Memorandum to the City of Markham Committee of Adjustment

File: A/091/20
Address: 34 Shady Lane Cres – Markham, ON (Thornhill)
Applicant: Tiago Dos Santos & Belinda Naccarato
Agent: SH Design
Hearing Date: Wednesday October 21, 2020

The following comments are provided on behalf of the West Team. The applicant is requesting relief from the following requirements of “Fourth Density Single Family Residential – (R4A)” under By-law 2150, as amended, as it relates to a front covered porch and building addition. The variances requested are as follows:

FRONT ELEVATION

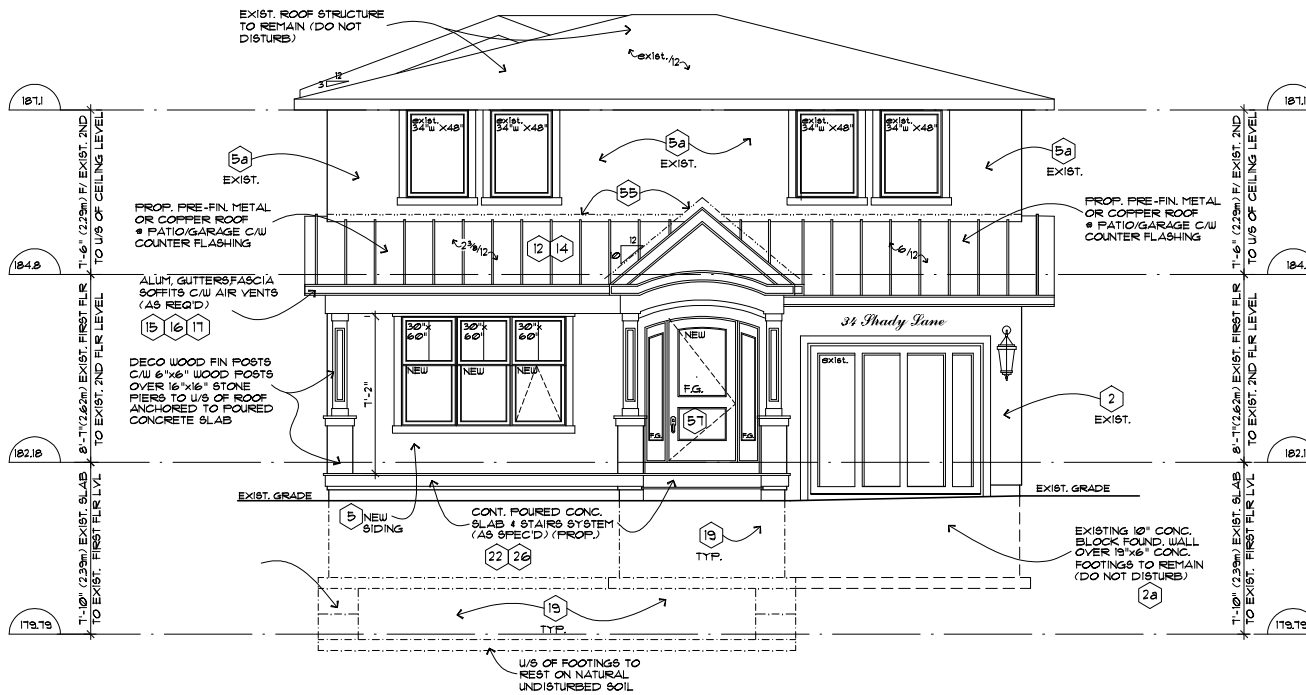
This requested variance relates to a proposed 6.33 m (20.77 ft) wide, one-storey covered front porch. Staff are of the opinion that the proposed covered front porch will not significantly add to the overall bulk and massing of the dwelling provided that it remains unenclosed.

1. That the covered front porch remains unenclosed;
2. That the variances apply only to the subject development, in substantial conformity with the batch stamped plans attached as Appendix "B" to this Staff Report, and that the Secretary-Treasurer receive written confirmation from the Director of Planning and Urban Design or designate that this condition has been fulfilled to his or her satisfaction;
